LS3P ASSOCIATES LTD.  
ADDENDUM NO. II  
January 20, 2012

# GATES COUNTY PUBLIC LIBRARY

GATESVILLE, NORTH CAROLINA  
P.N. # 8702-101650

<b>REVISE CULVERT AND DRAINAGE DITCH</b>
SCALE: 1" = 30'
<b>BD-C-04</b>

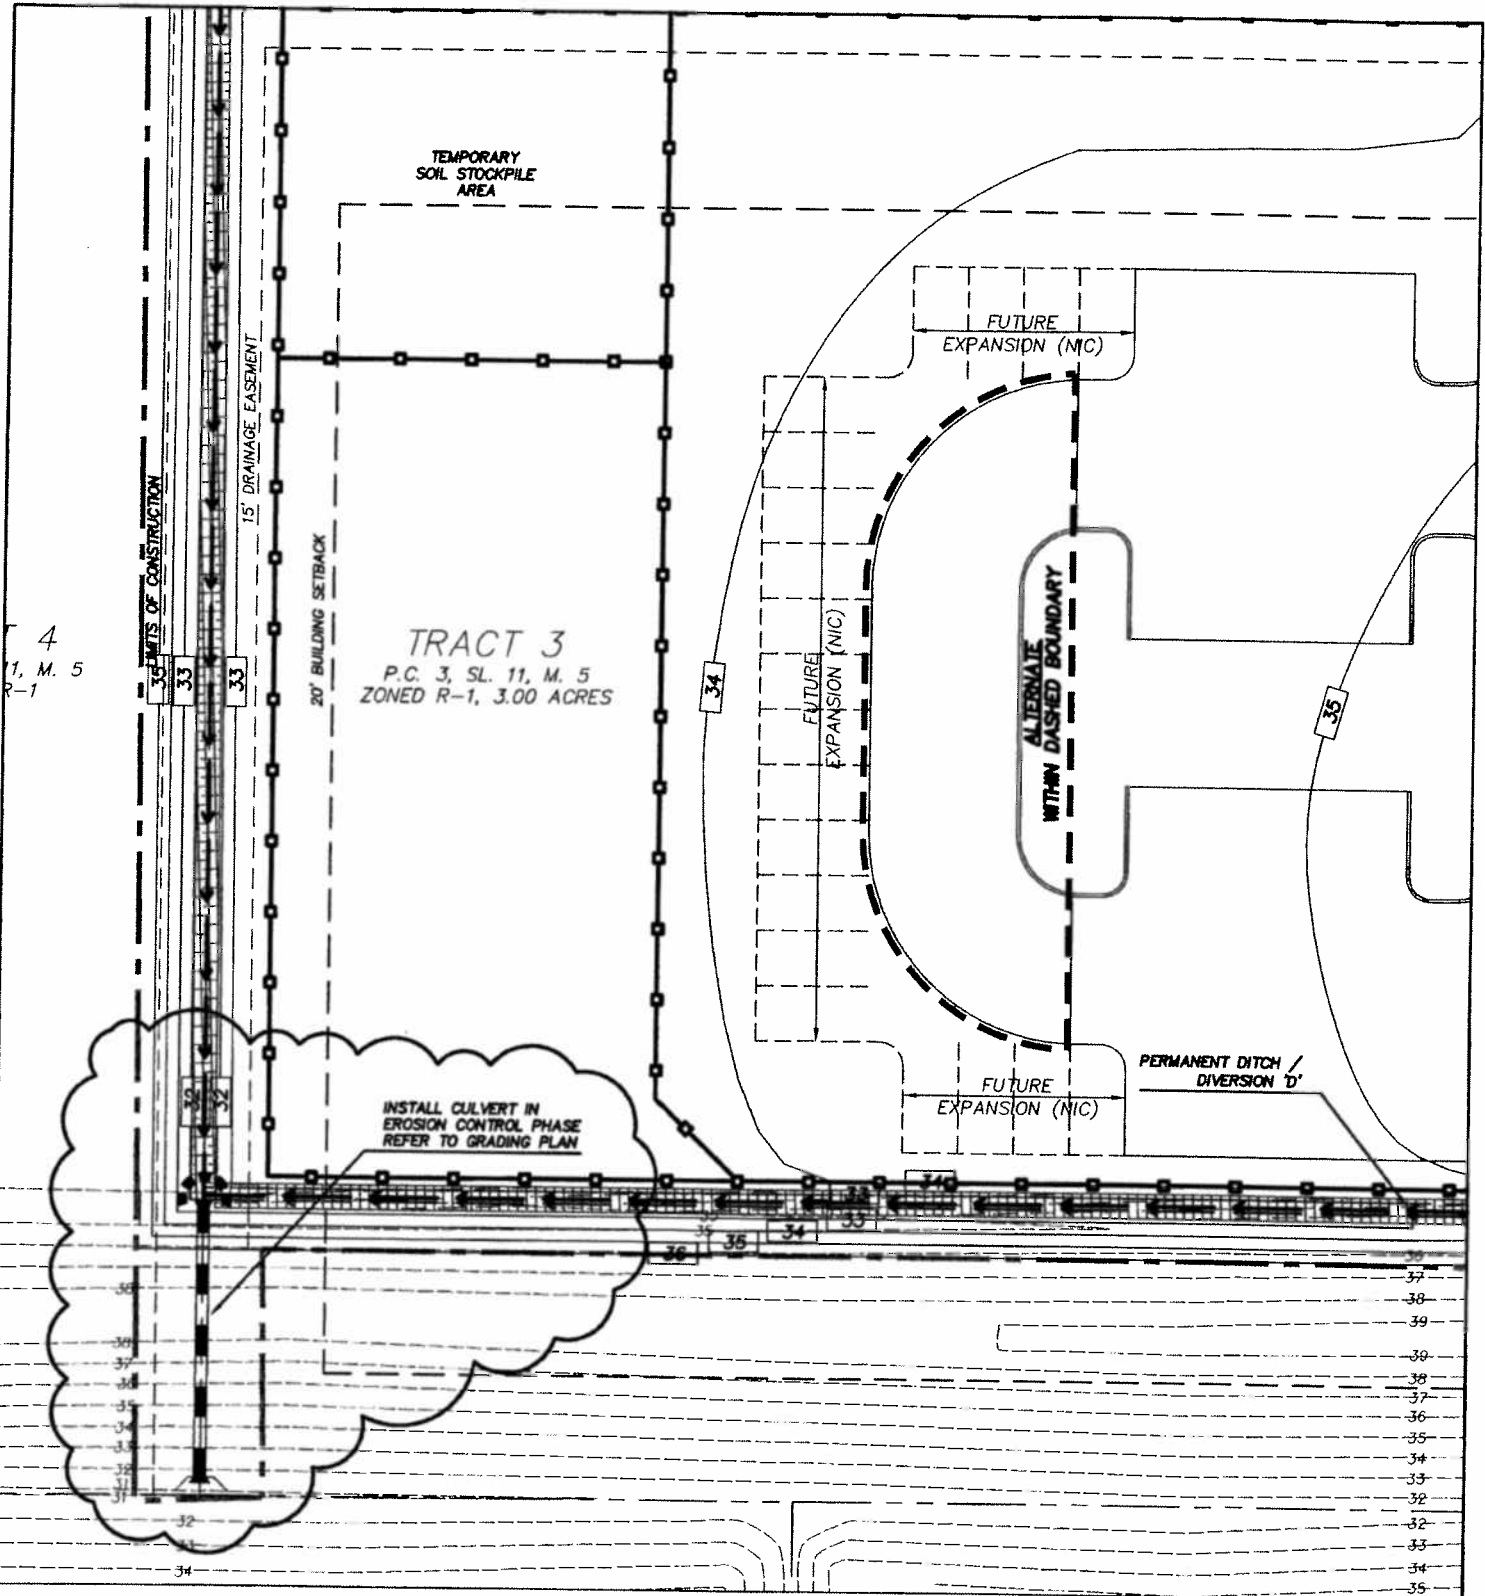
- A. Add additional proposed spot grades, Revise culvert, and Revise proposed grading and ditches to work with new existing contour data, as indicated on sketches BD-C-03 and BD-C-04.
- B. Revise the label: "Provide scheduled value of all work within the dashed boundary on the bid form. Also refer to other plan sheets for extent of work" to the following: "Provide the TOTAL COST of all work within the dashed boundary in the BASE BID BREAK-OUT PRICING SECTION on the bid form. Also refer to other plan sheets for extent of work AND INCLUDE THE COST FOR THAT WORK IN THE TOTAL"
